IREDELL COUNTY HEALTH DEPARTMENT

IMPROVEMENT PERMIT / AUTHORIZATION TO CONSTRUCT / OPERATION PERMIT / EXISTING SYSTEM

PERMIT # 217416

SITE ADDRESS: 223 Harbor Ridge Drive Statesville, NC 28677

AS BUILT SKETCH

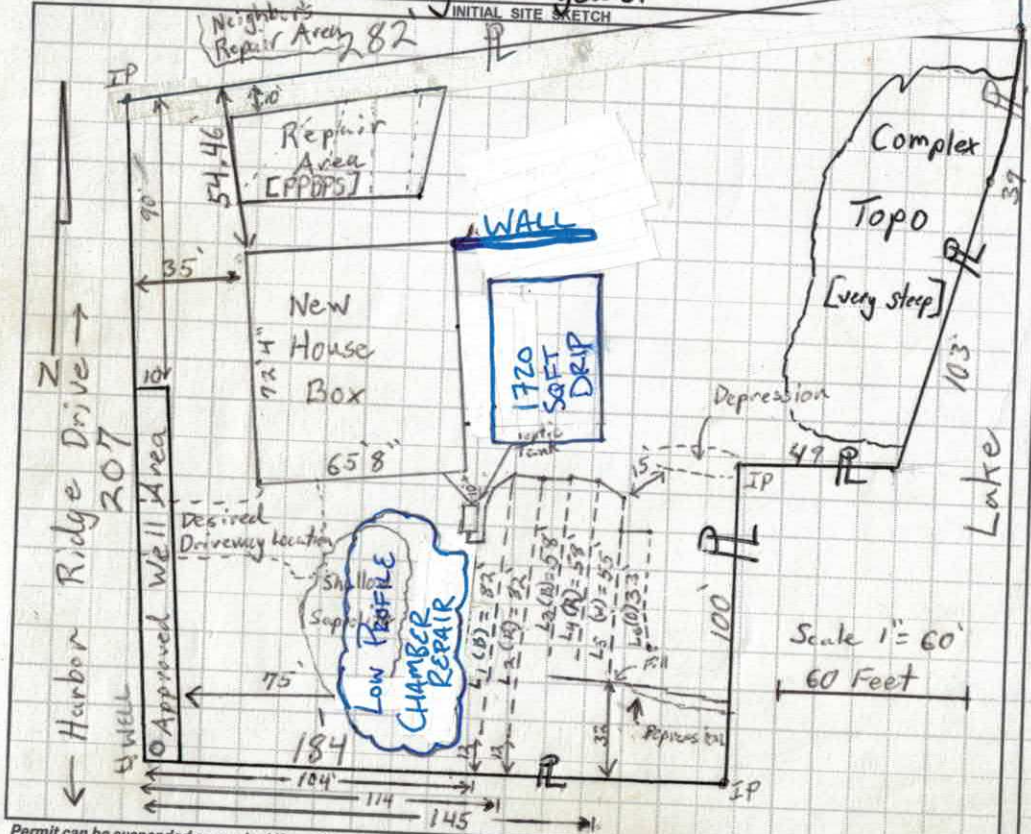
Though 368 l.f. of line laid out, only 360 l.f. need be installed. As this application documentation depicts a driveway (proposed) crossing an already approved well area, it is strongly recommended that the owner closely coordinate with the well driller + builder to ensure the well is not drilled in the desired driveway area.

2ND LINE SILTED IN AFTER RAIN. ALL CHAMBERS REMOVED & SILT REMOVED BA

REPAIR AREA CHANGED DUE TO RETAINING WALL BA

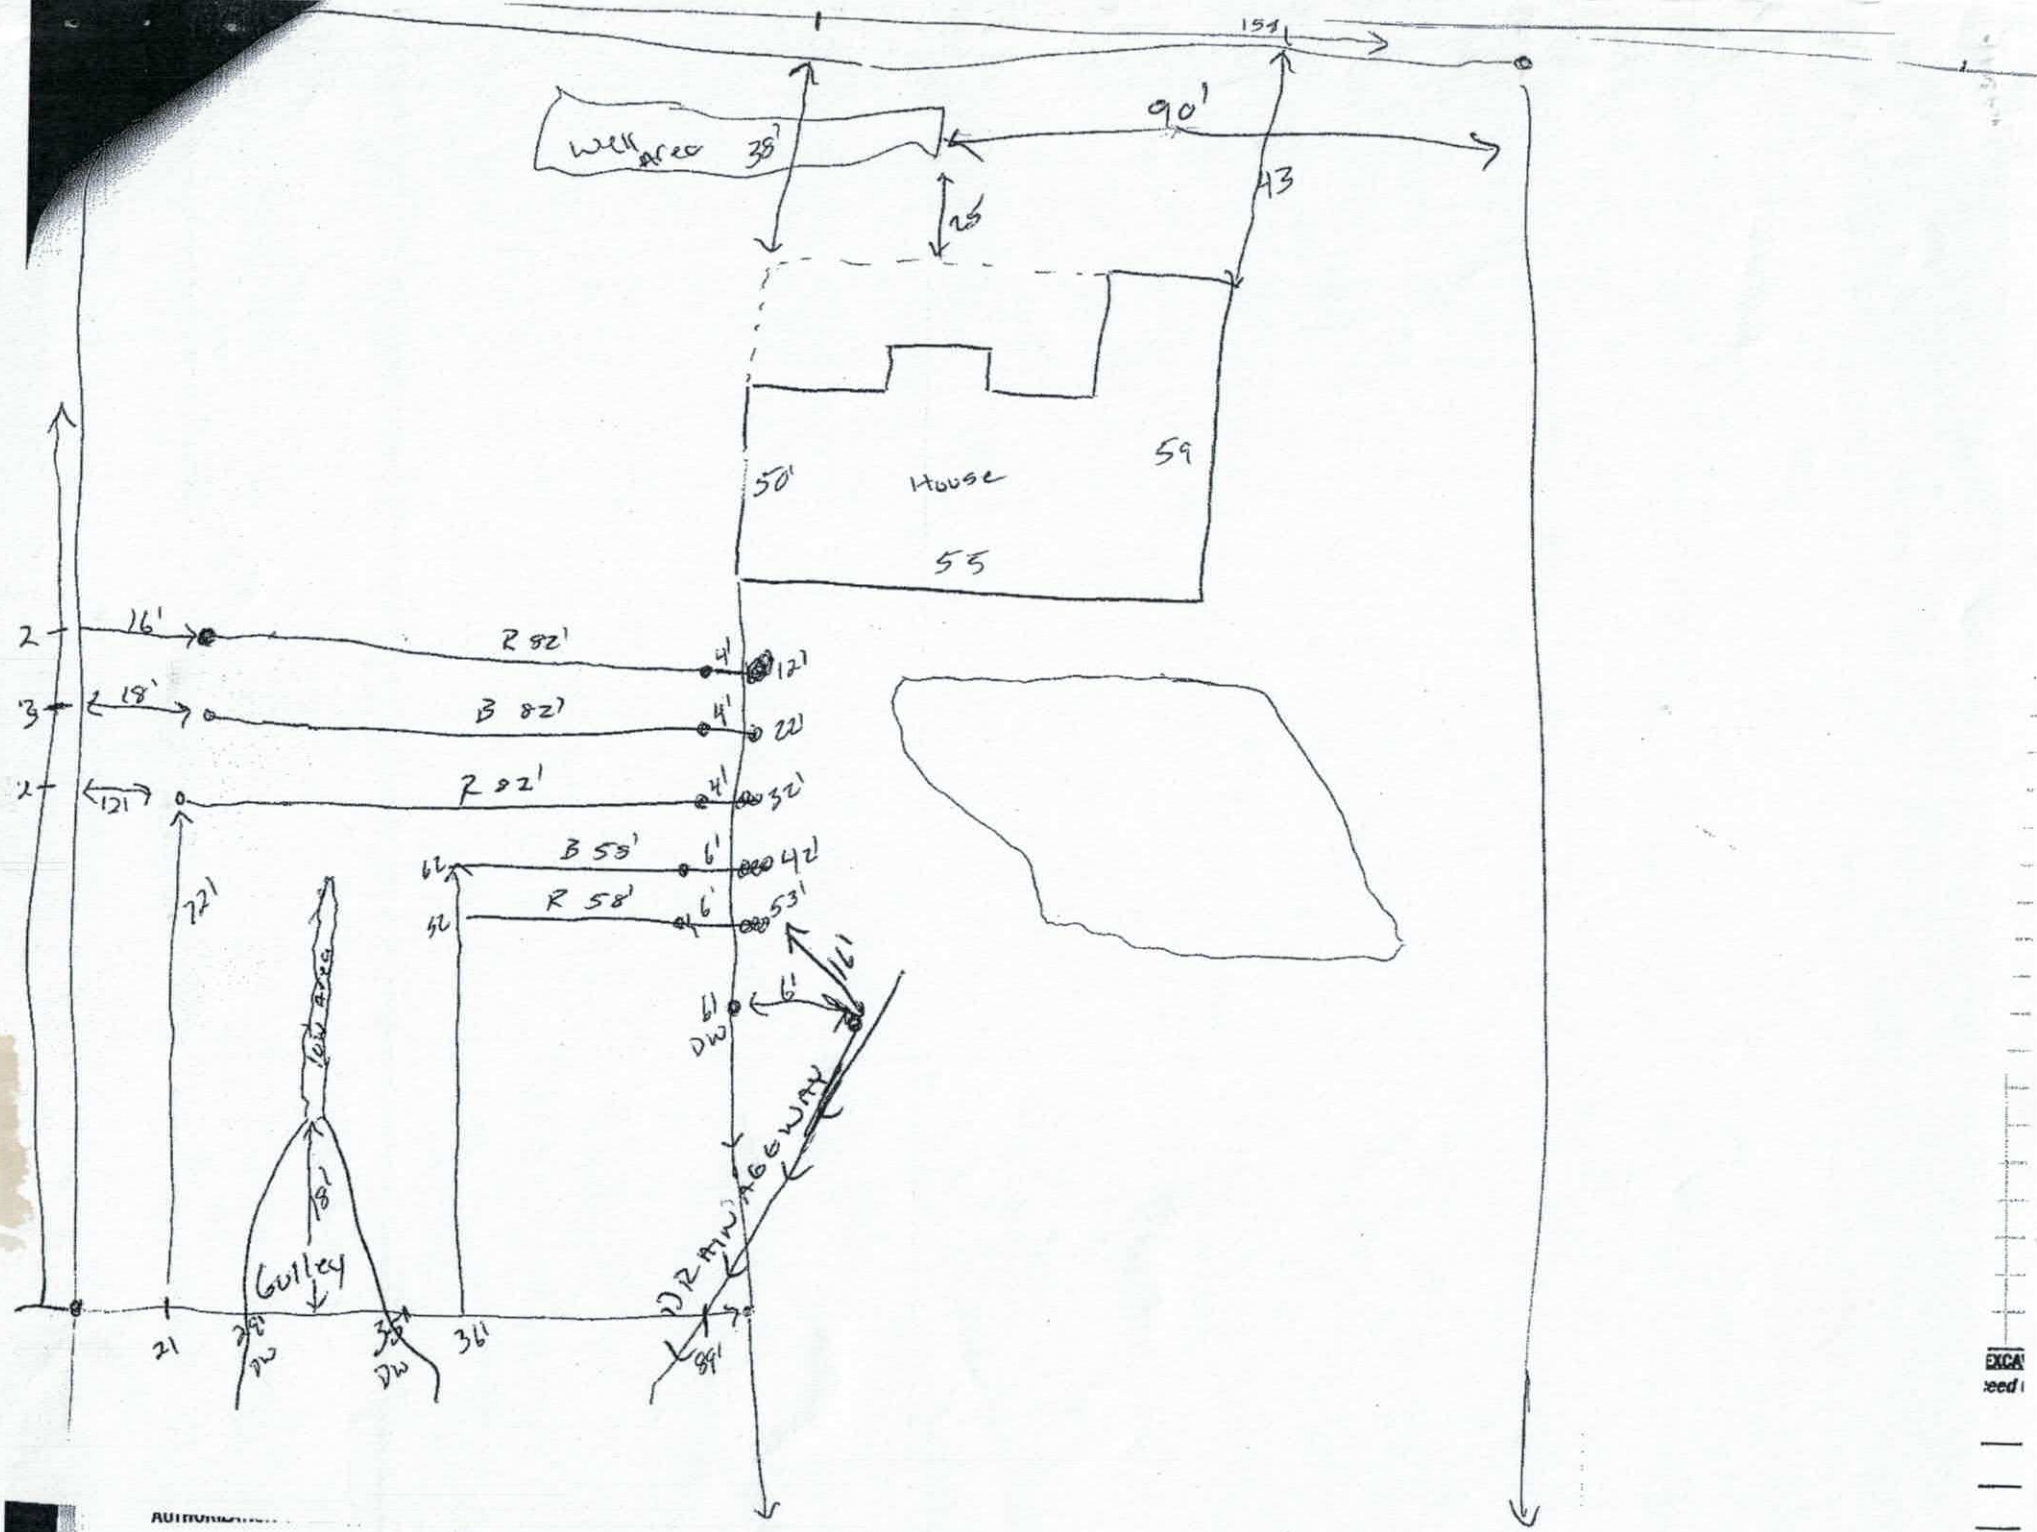
146
~~160~~ gallons Repair (0.25 Ltar @ 25% reduction
→ 110 L.F. of 25% reduction
240 gallons → 120 L.F. of 50% reduction (or
1400 Sqft of Drip (0.1 Ltar).

2
82
82
58
58
55
30
365 (360 required)

30% slope = 25" install

OK
